LOSS CONTROL BULLETIN

MFG: MANCO PRODUCTS, INC.
 NAME: ROUND UP - *FOLD*
 TYPE: NON-KIDDIE

EMERGENCY ALERT ON THE RIDE, "ROUND-UP"
 (by Manco, Hrubutz Mfg, or Kilinski Mfg)

BULLETIN: BU-134 MC

NO. PD-35-R

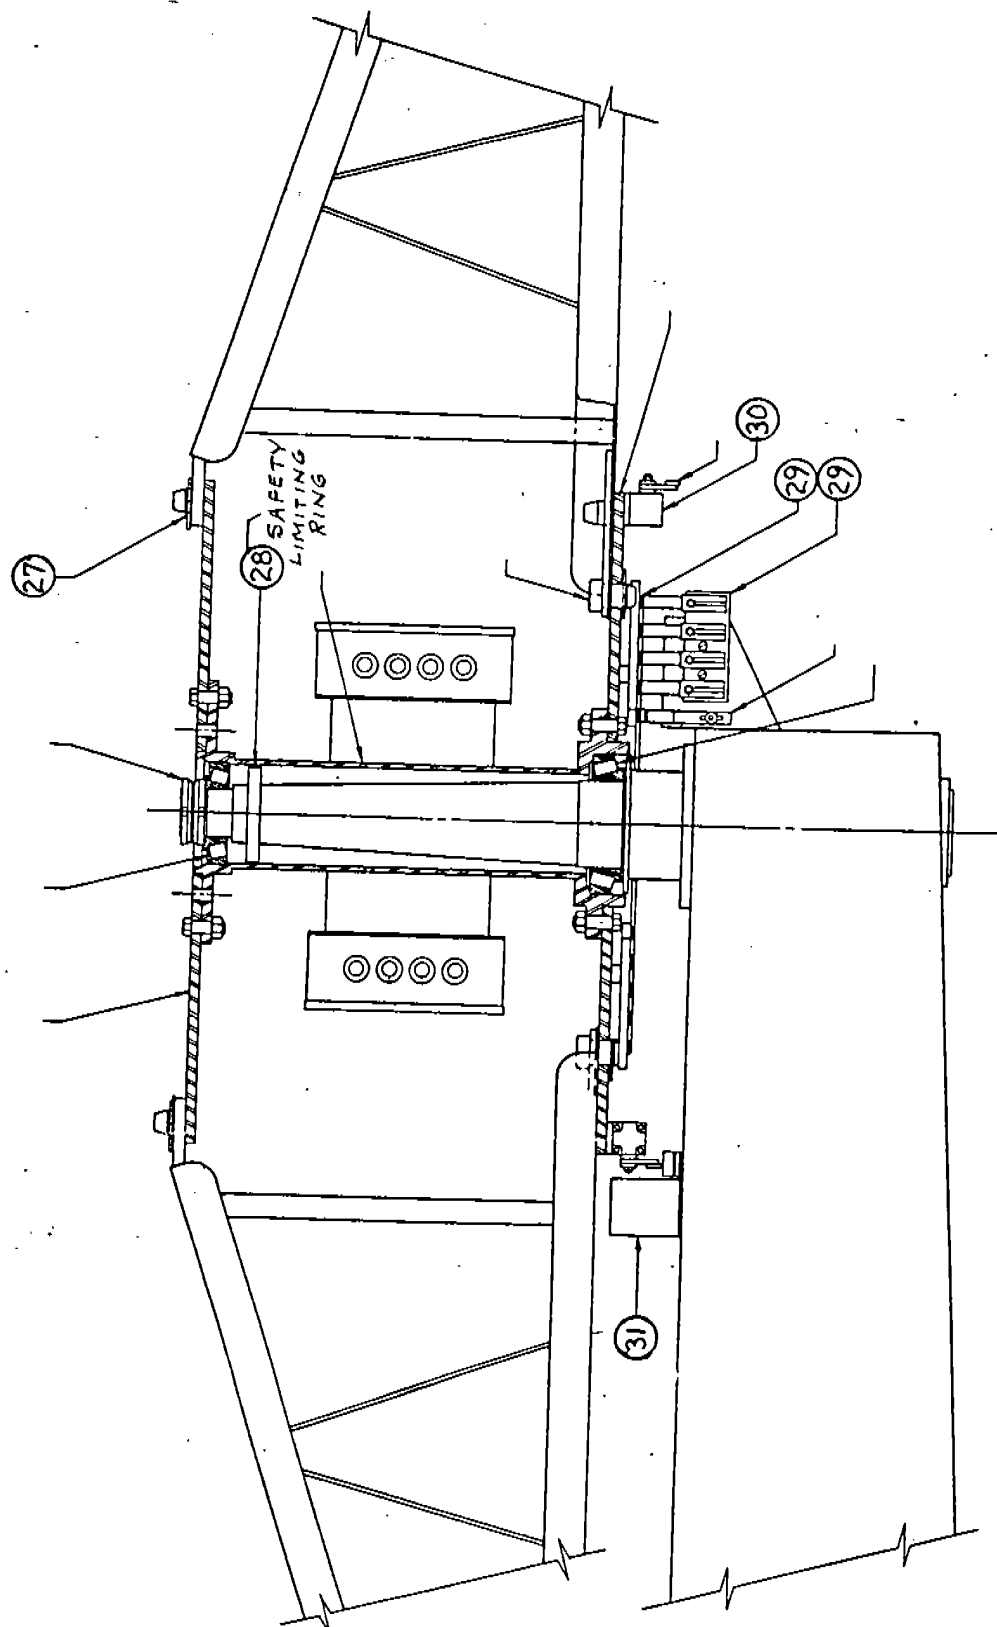
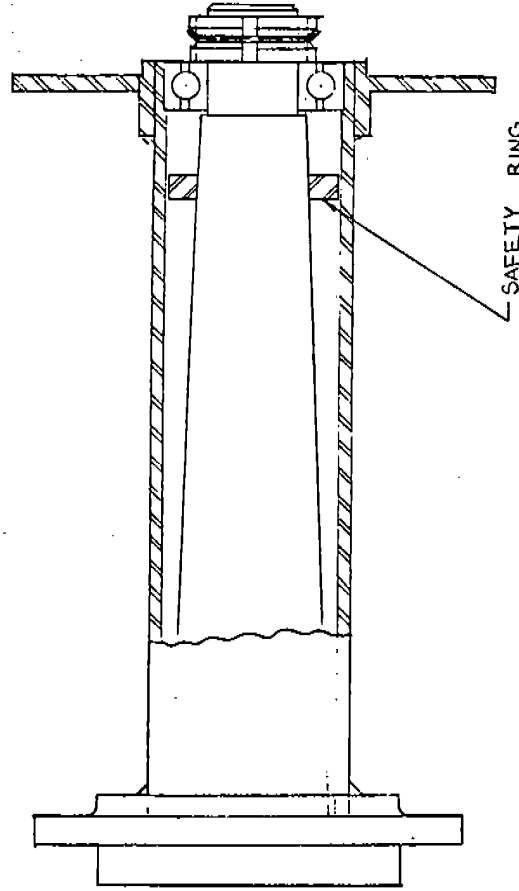
We feel it is necessary for you to take the following preventive measures immediately: (See enclosed drawings RD-35R and FR-503S.)

1. Remove the center ornament and inspect the weld on the hub (shown in drawings RD-35R and FR-503S) for cracks. If there are cracks, ship the hub to Man-Co Mfg.. We will repair, using the design presently being used.
2. Remove the top bearing and visually inspect the bearing and make sure there is a safety limiting ring in place. If there is a limiting ring on your ride, it will be plainly visible on the upper portion of your main spindle shaft. If it is not present, we highly recommend that you add this part immediately. (Part #STD 353)

BEFORE INSTALLING A NEW BALL BEARING, ON A RIM DRIVE PARATROOPER MAIN SPINDLE, PUT A SAFETY RING ON THE SHAFT WITH THE TAPER CONFORMING WITH THE TAPER ON THE SHAFT. THE RING IS TO PREVENT THE HUB FROM COCKING TO ONE SIDE IF THE BEARING FAILS.

CENTER HUB - INSPECTION OF WELDS
ROUND-UPS & PARATROOPERS

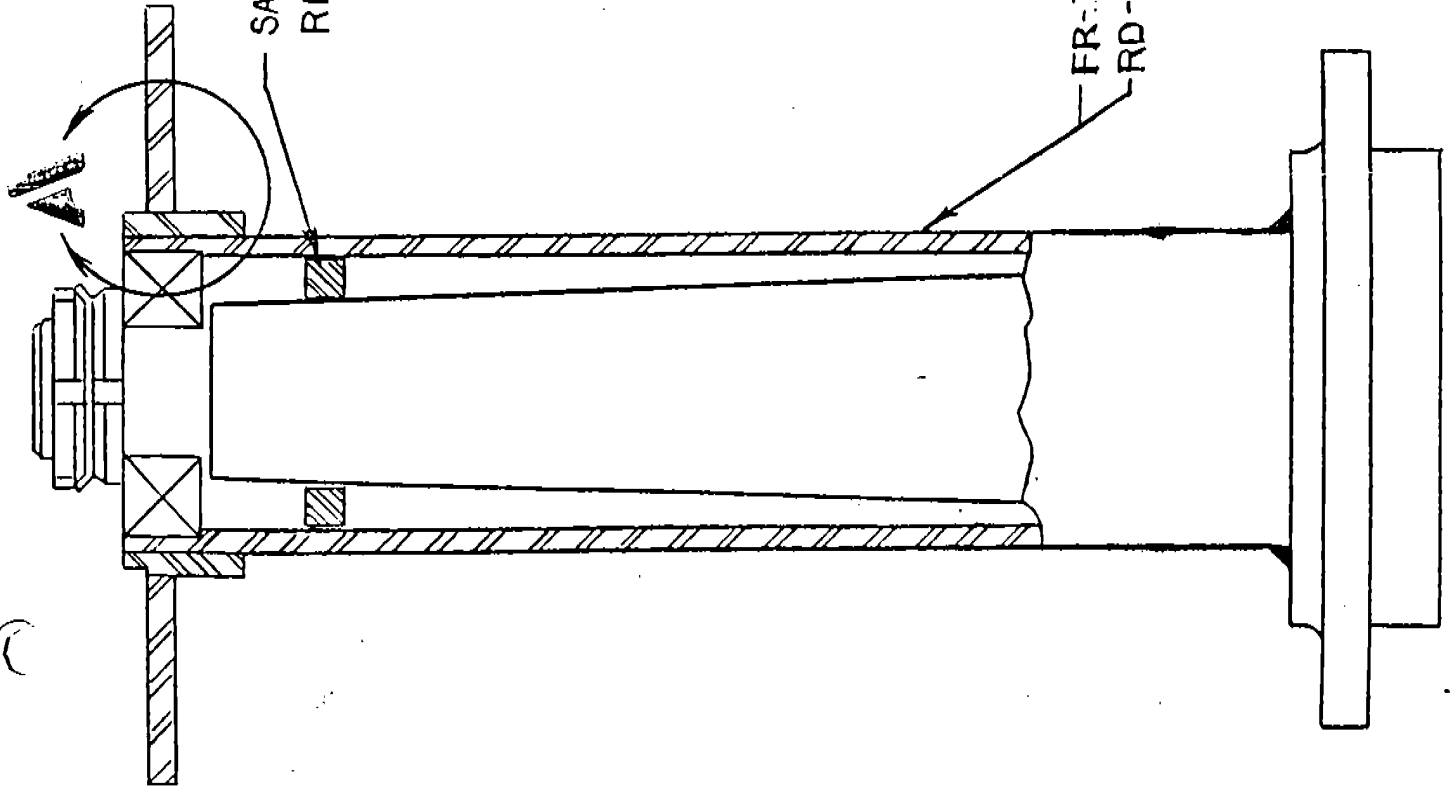
The main spindle shaft hub housing on the Round-Up and Paratrooper amusement rides that were manufactured by Frank Hrubetz Co., and Kilinski Mfg. Co. (KMC) have shown some sign of fatigue cracks in the weld areas of the hub assemblies.

IF CRACK IS
NOTED IN THIS
AREA, CENTER HUB
SHOULD BE REPLACED

30' FOLDING ROUND-UP	ANCHOR SHAFT
----------------------	--------------

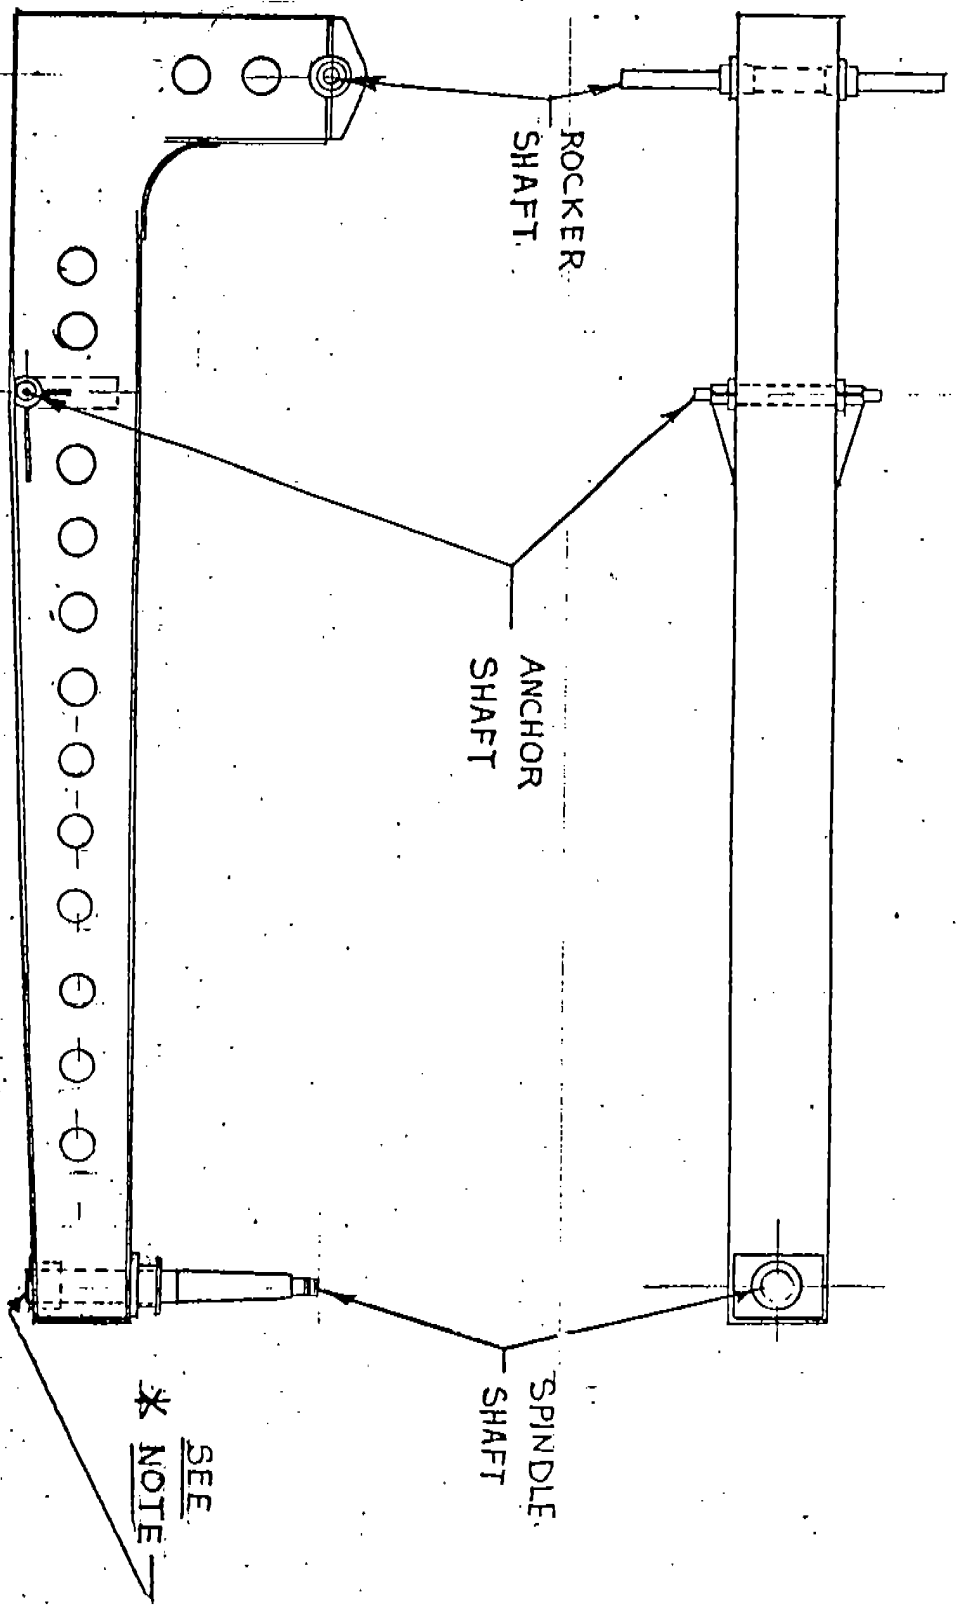
*NOTE: IF NO SHRINK COLLAR IS VISIBLE AT BOTTOM OF BOOM, THEN REPLACEMENT OF SPINDLE SHAFT IS NEEDED.

- 1) Inspect your ride and determine if the shafts and/or spindles are welded in directly, or if shrink collars are used. (See Drawings BU-138-A through F for information on how to determine the installation method used on your ride.)
- 2) If shrink collars are used on your ride, there is no need for replacement. Please note: All shafts and spindles still need to be tested annually according to the procedures outlined in BU-135-MC (QC-UI-1 - Rev. 3).
- 3) If the shafts and/or spindles on your ride are welded directly to the boom, then replacement is needed.

CYL. ANCHOR SHAFT

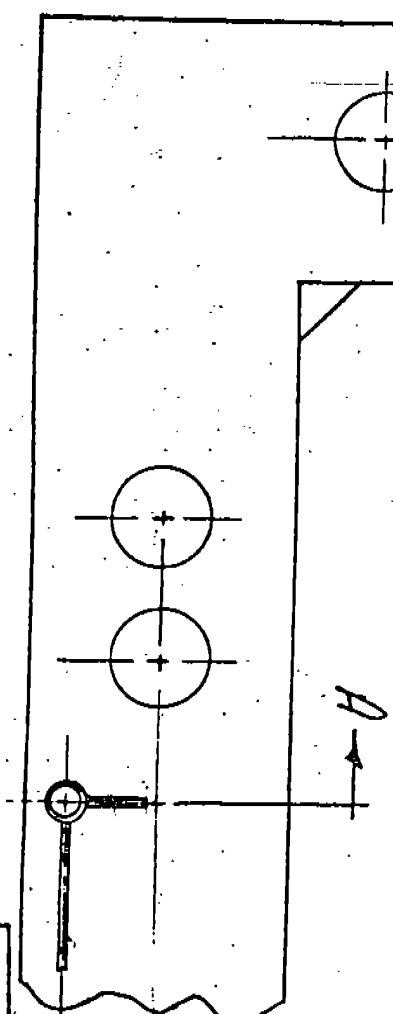
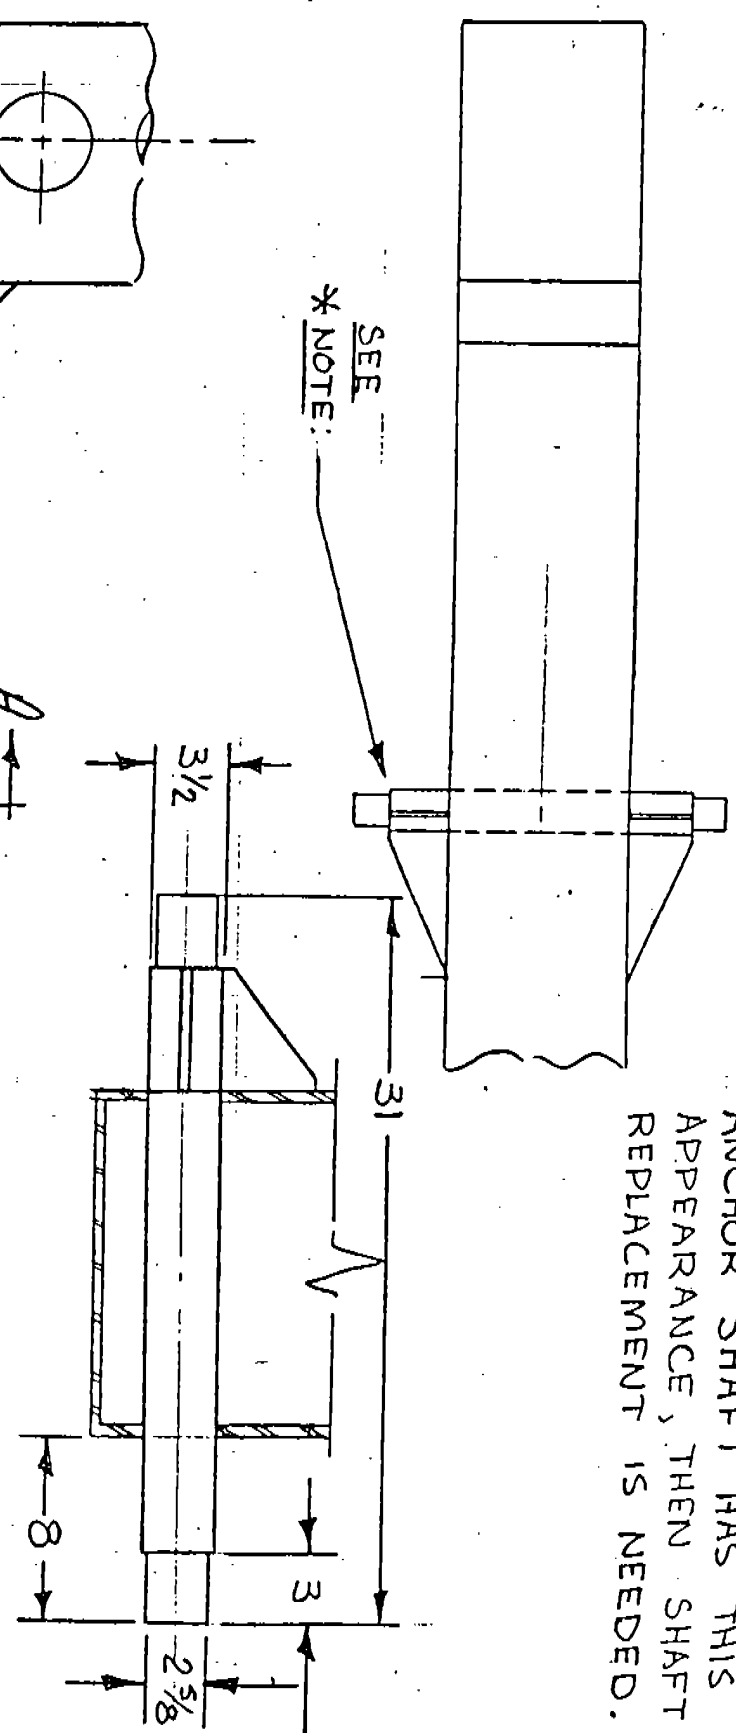
* NOTE: IF CYLINDER ANCHOR SHAFT HAS THIS APPEARANCE, THEN SHAFT REPLACEMENT IS NEEDED.

MAIL BOOM ROCKER SHAFT

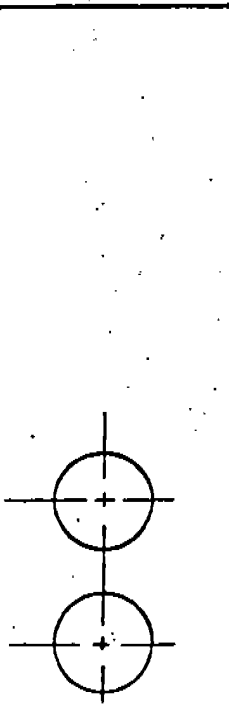
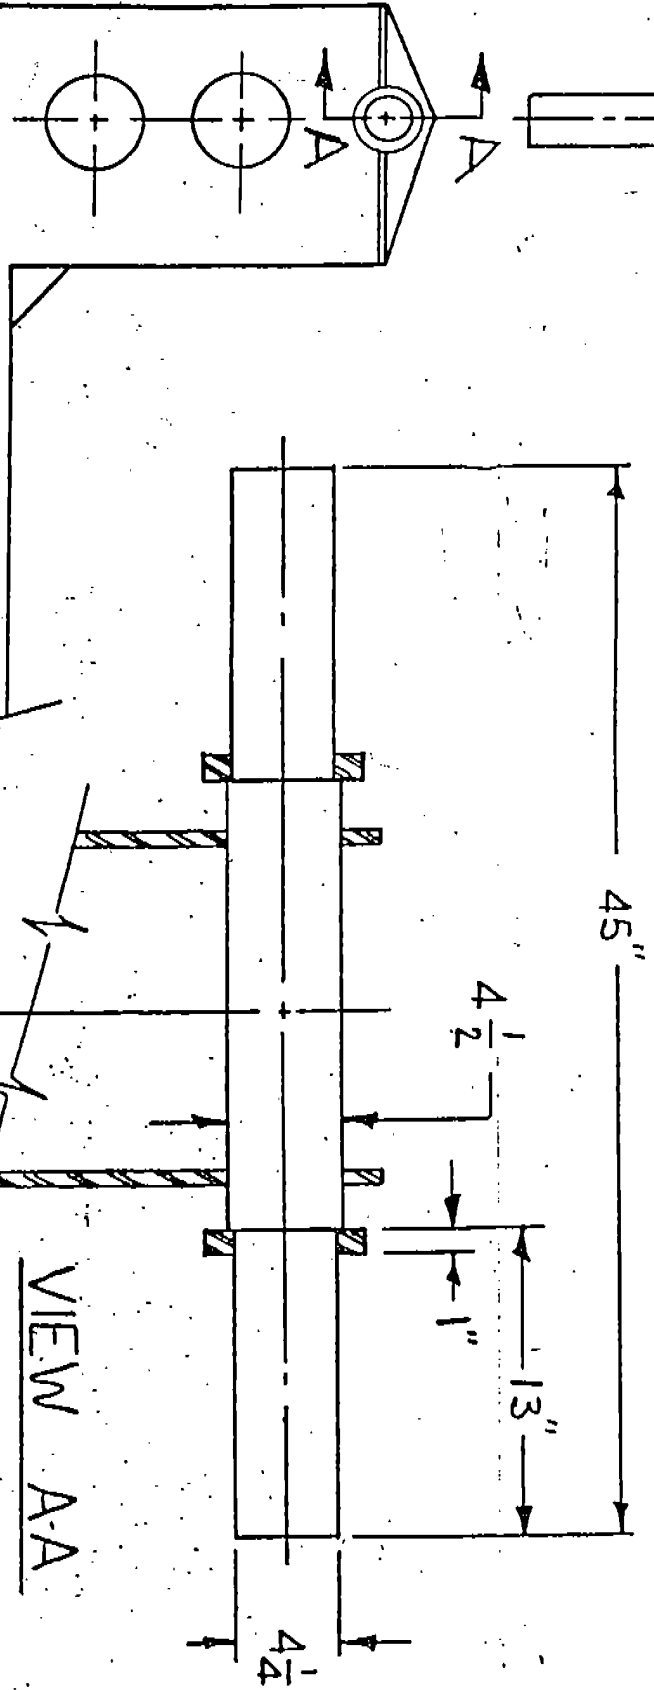
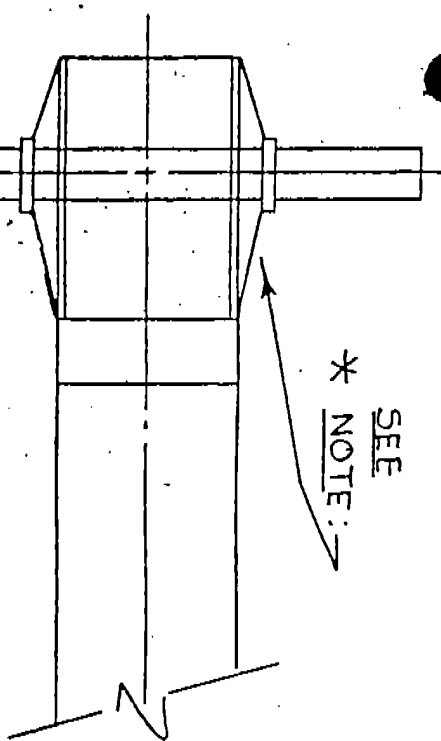
* NOTE: IF ROCKER
SHAFT HAS THIS APPEARANCE
THEN REPLACEMENT OF SHAFT
IS NEEDED.
